PREVOST

MAINTENANCE Mi11-16 **INFORMATION**

SUBJECT: ADDITION OF A RESISTOR ON EVAPORATOR

COMPARTMENT FAN SPEED CONTROL CIRCUIT WHEN REPLACING A53 OR A54

FIGURE 1

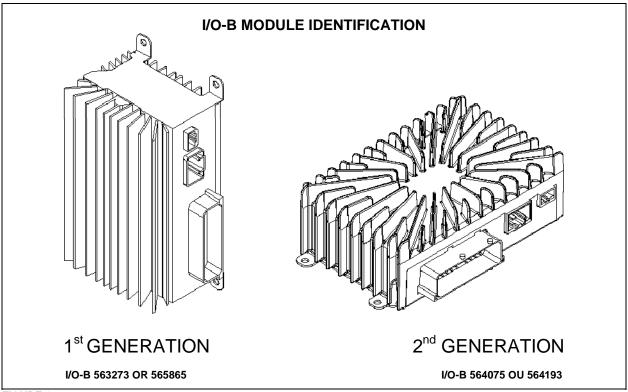
This procedure is needed only when proceeding to the replacement of <u>first generation</u> A53 (H3-41, H3-45, X3-45) or A54 (XLII MTH, H3 VIP) multiplex module with <u>second generation</u> module (see figure 1 for module generation identification). In this case, addition of a 3650Ω resistor parallel to circuit 131 (evaporator fan 2^{nd} speed) is required. Without the addition of this resistor, evaporator fan might not run in second speed (fast).

FIGURE 3

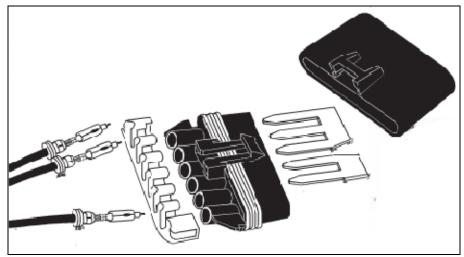
- 3. Place a cable seal 561565 on the motor white and crimp terminal 564136.
- 4. Crimp ring terminal 561964 to one end of black 18 AWG wire. Place a cable seal 561565 and crimp terminal 564136.
- 5. Place a seal 561840 to each end of resistor 562306 and crimp terminal 564136 to each end. Insert the resistor assembly in the heat shrinking tube and heat.
- 6. Cut the common bar 6-position 564138 in order to have one common bar 2-position and one common bar 3-position (figure 3).

FIGURE 4

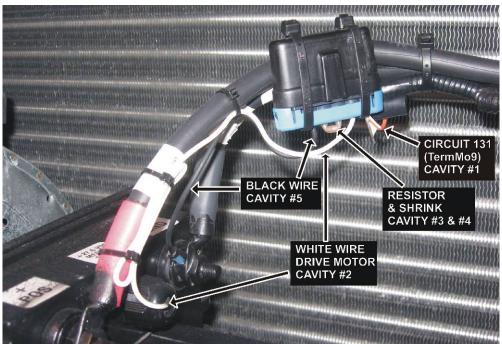
7. Perform connections as per figure 4. Insert plug 561783 into cavity #6.
